ARCHITECT'S SUPPLEMENTAL INSTRUCTIONS

Project:	Lumberyard District – Buildings 2, 6, 8 & 9 Omaha, NE	Initiated By		Distributed To	
Project Number:	15927	<input type="checkbox"/>	Owner	<input checked="" type="checkbox"/>	
Owner:	Lanoha Development	<input type="checkbox"/>	Architect	<input checked="" type="checkbox"/>	
To Contractor:	Overland Constructors 5036 South 135 th Street Omaha, NE 68145	<input type="checkbox"/>	Contractor	<input checked="" type="checkbox"/>	
		<input checked="" type="checkbox"/>	Consultant	<input checked="" type="checkbox"/>	
		<input type="checkbox"/>	Field	<input type="checkbox"/>	
		<input type="checkbox"/>	Other	<input type="checkbox"/>	
Supplemental Instruction No.:	004				
Date:	July 8, 2016				
Contract Date:	February 15, 2016				
Contract For:	New Construction				
By:	Holland Basham Architects

Description: Revise data locations and deck light fixtures in the units.

1 ENLARGED TYPICAL UNIT C1 - ELECTRICAL

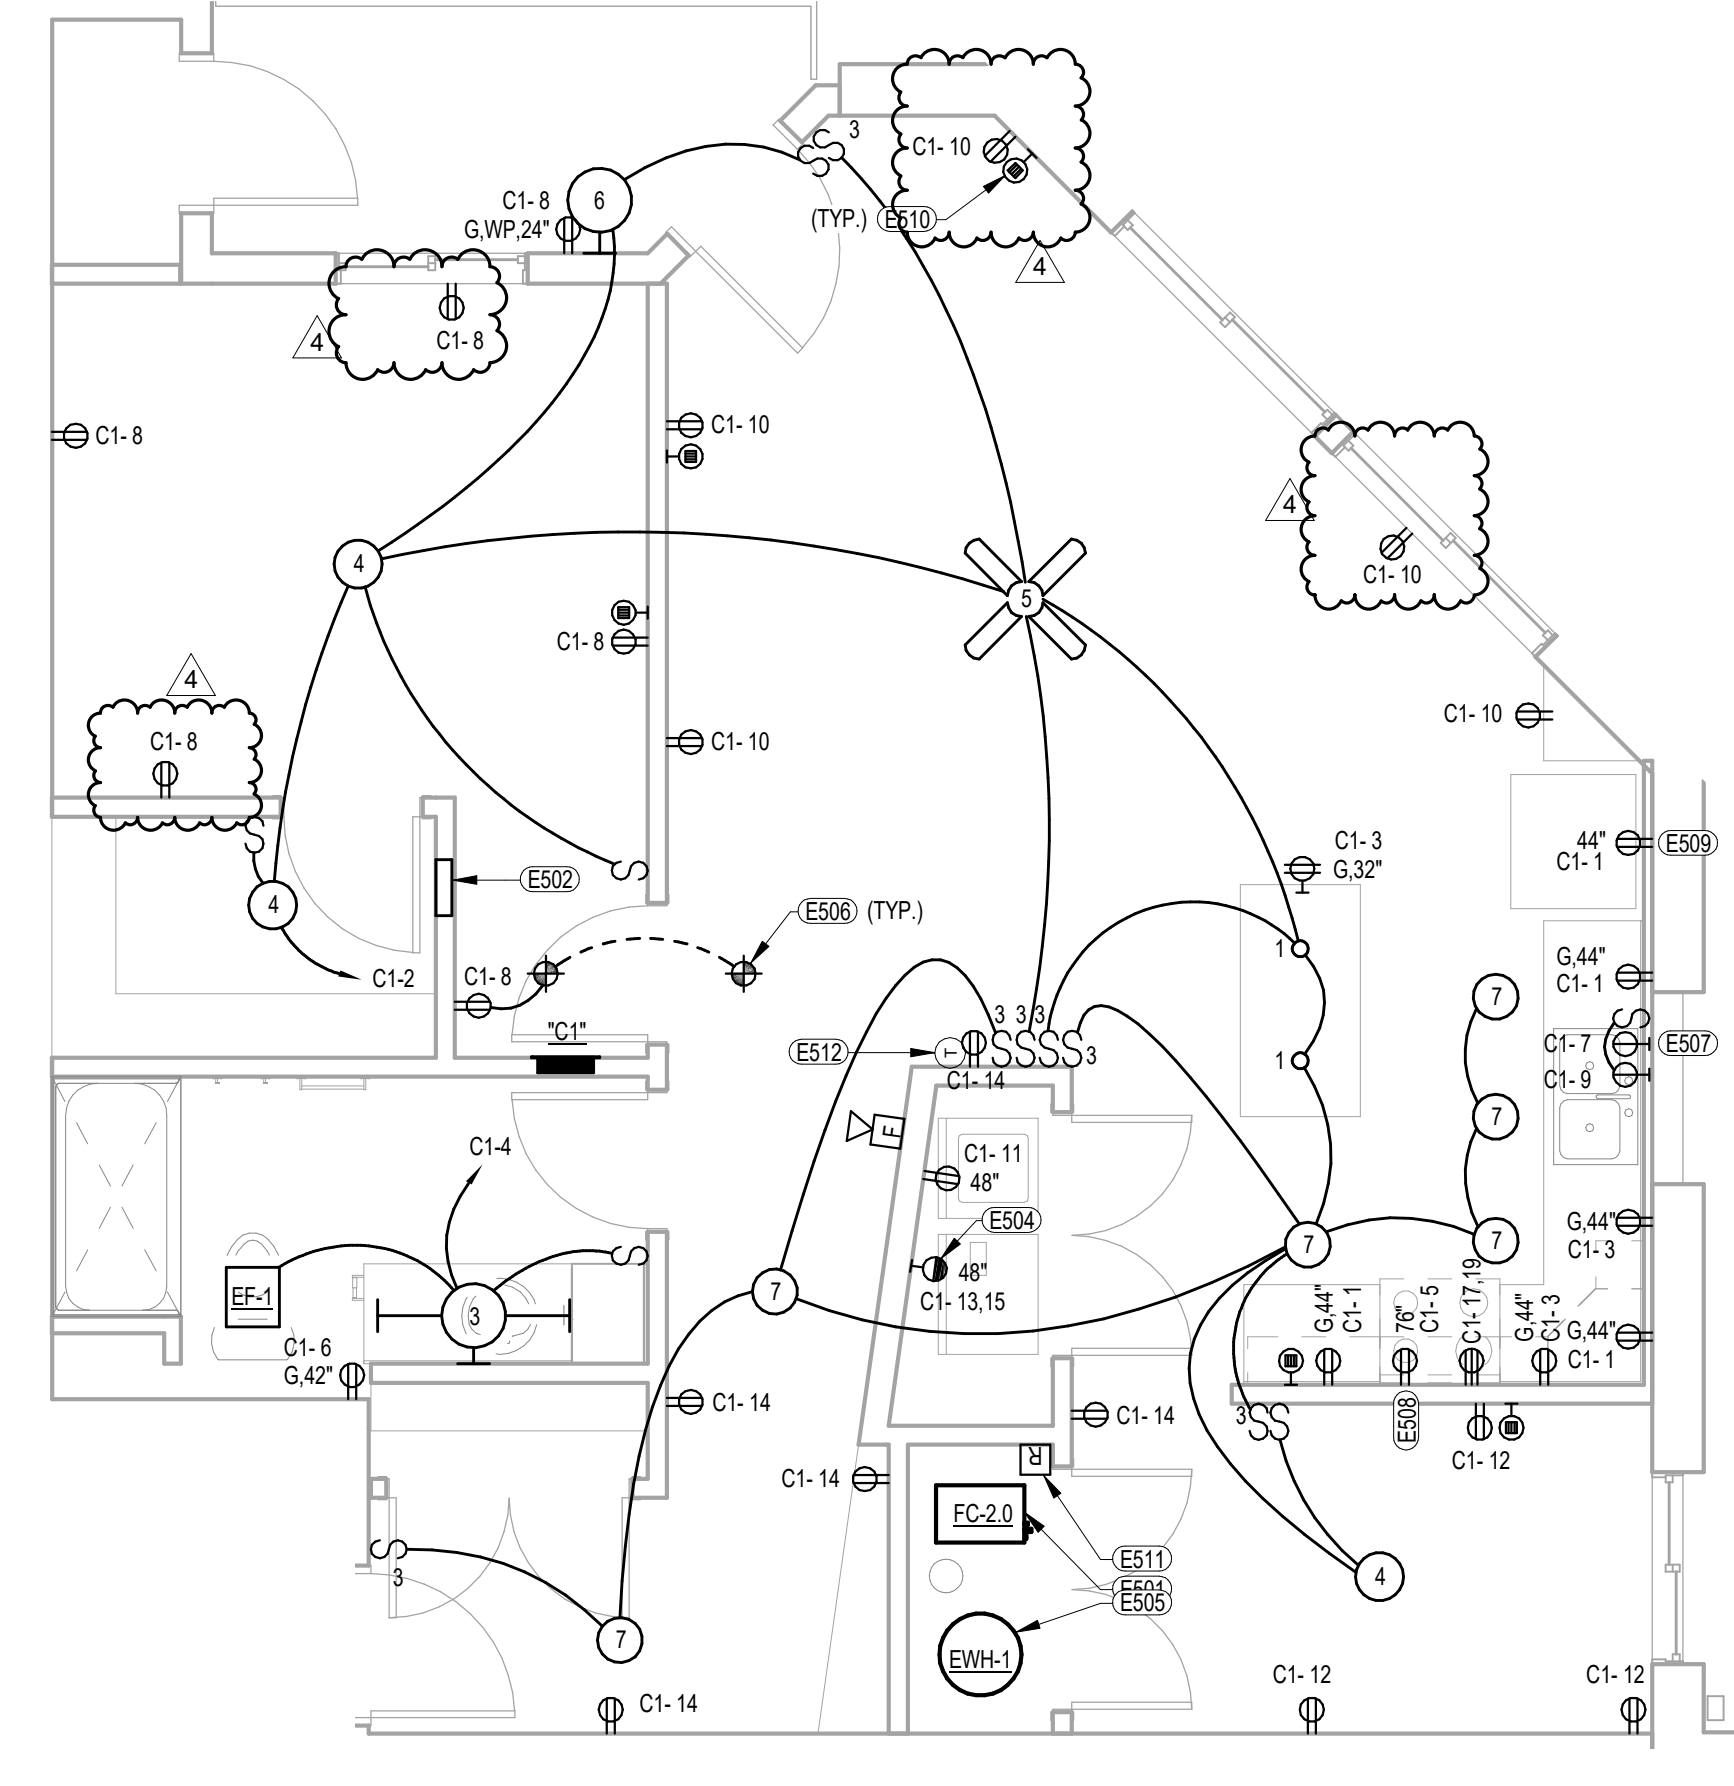
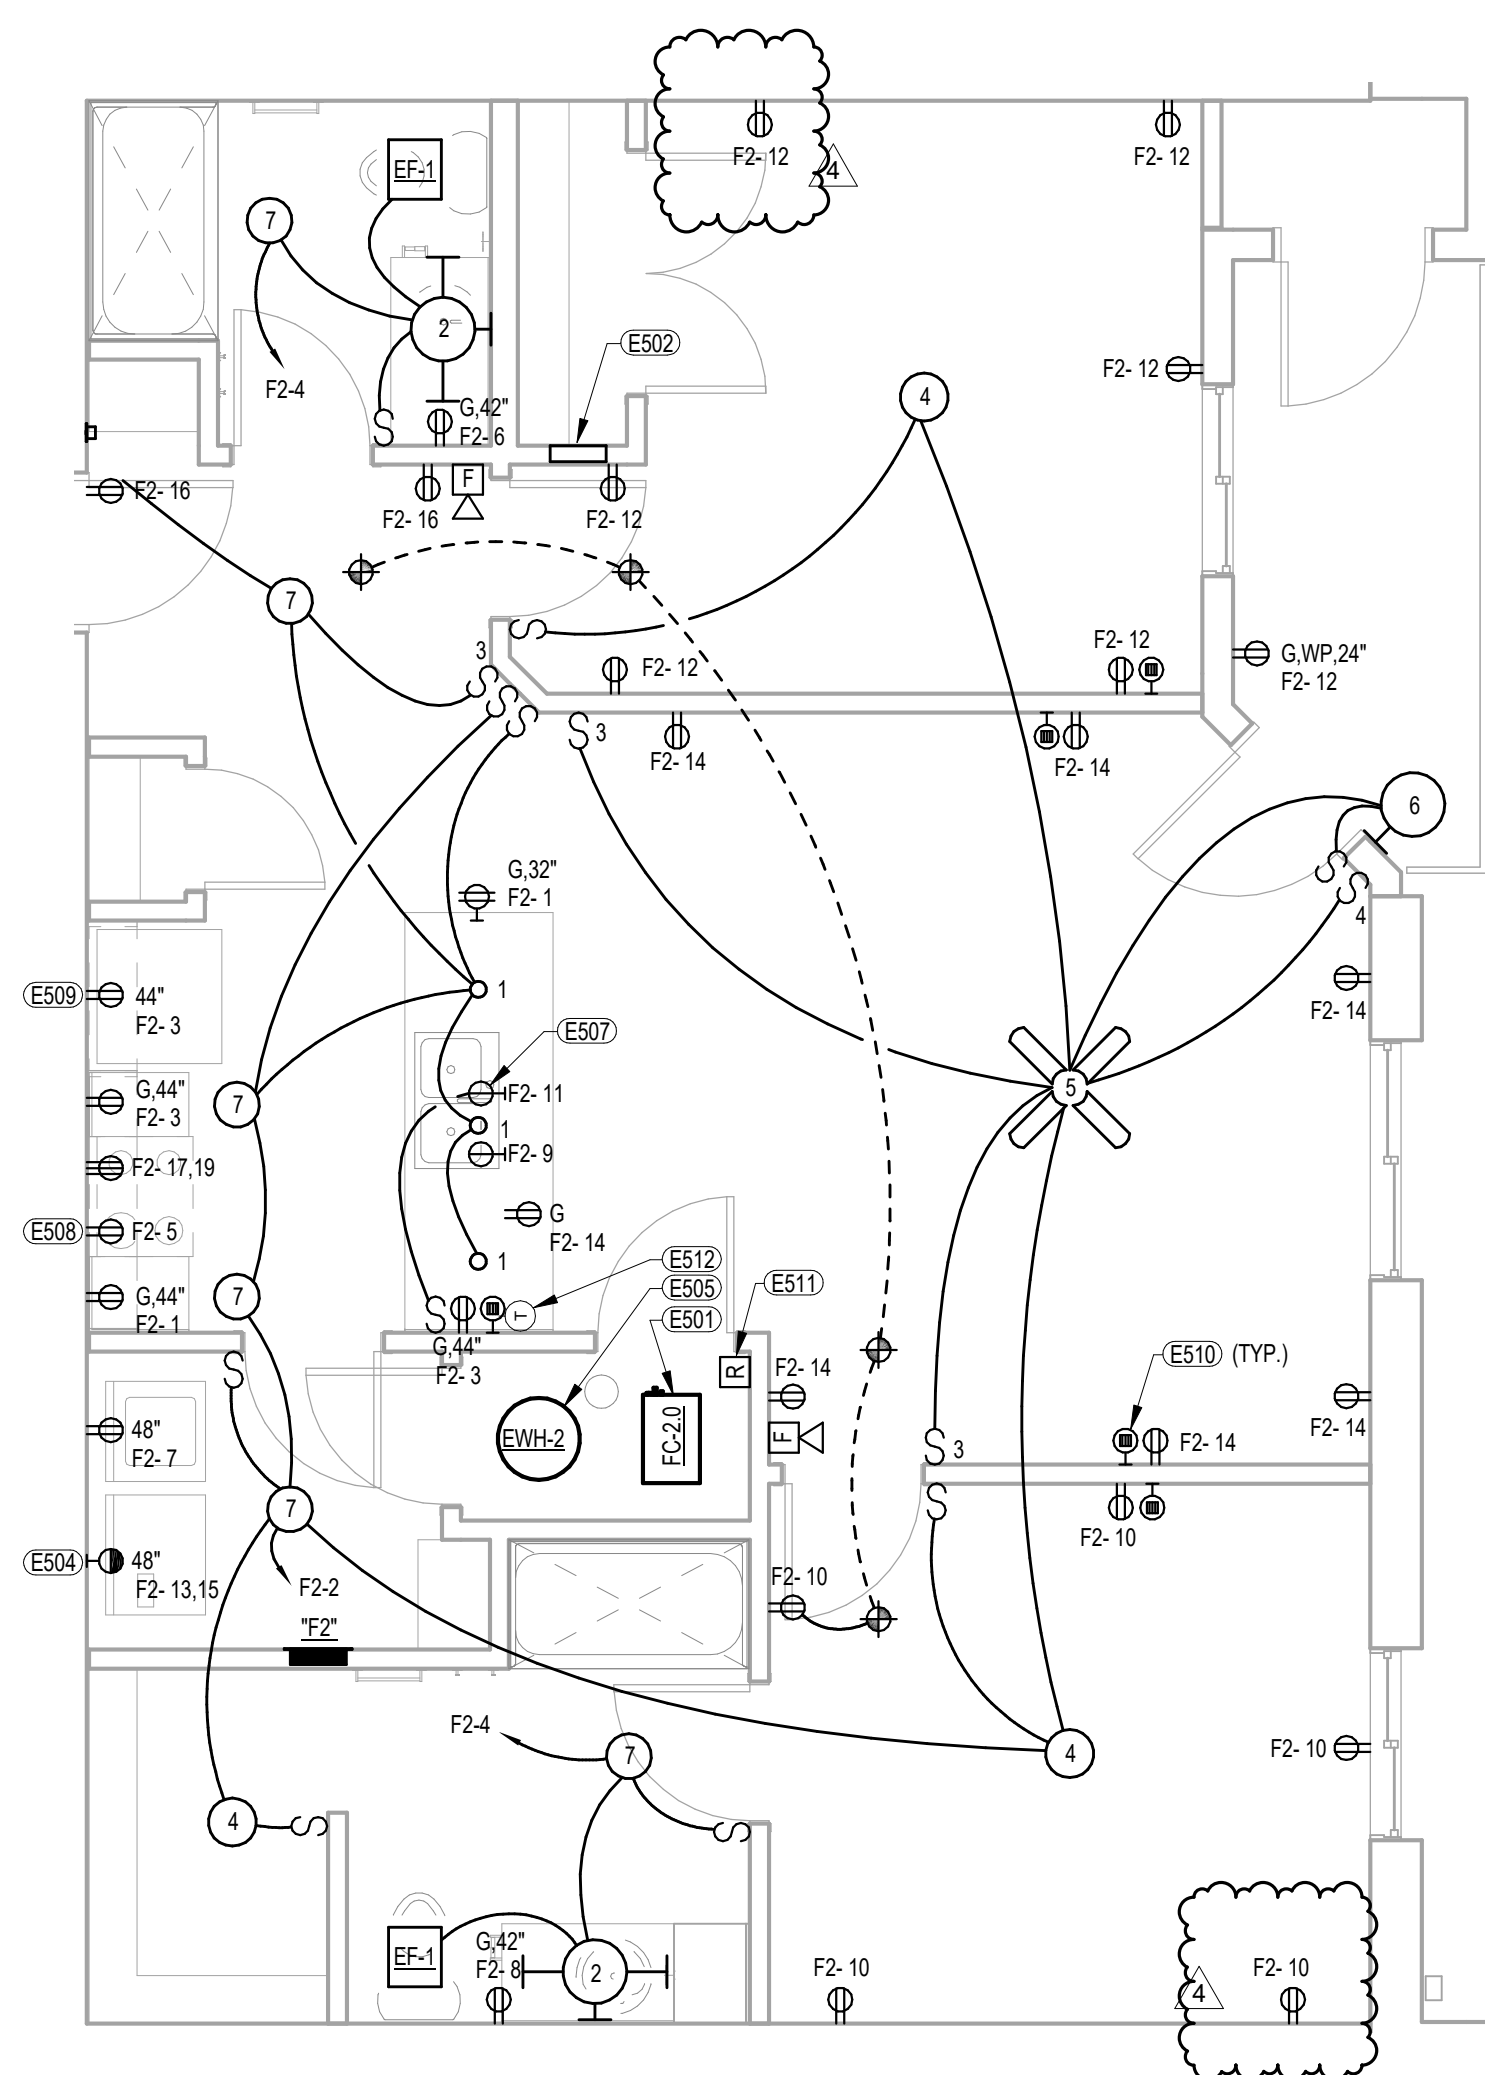
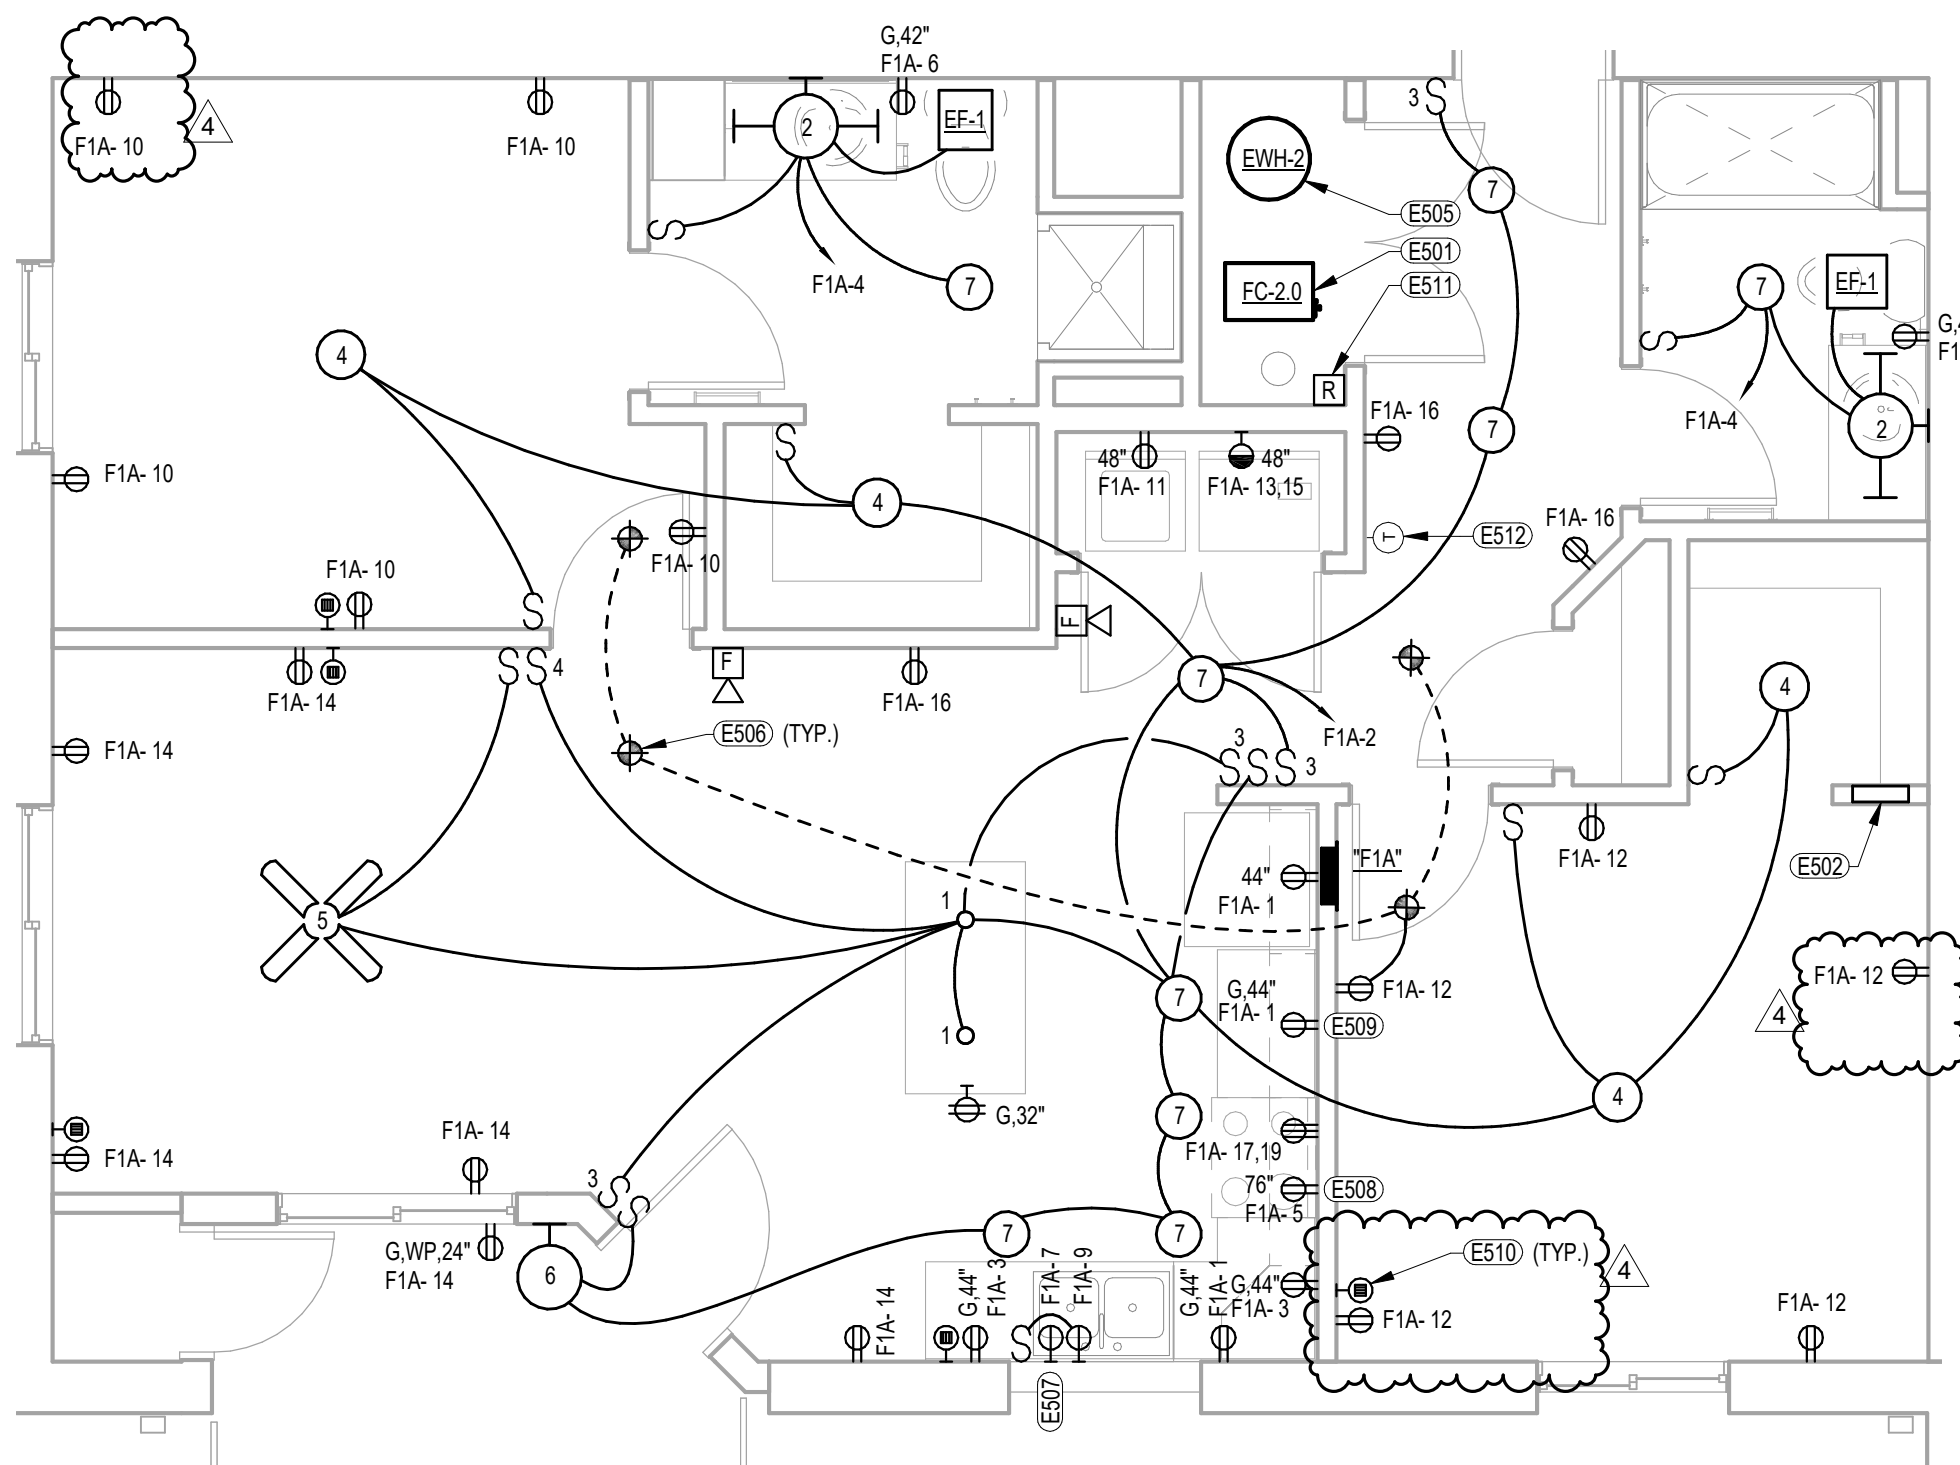
2. Sheet E6.02 – Enlarged Unit Plans - Electrical
 - a. Revise unit plans as shown in the attached Sheet E6.02.
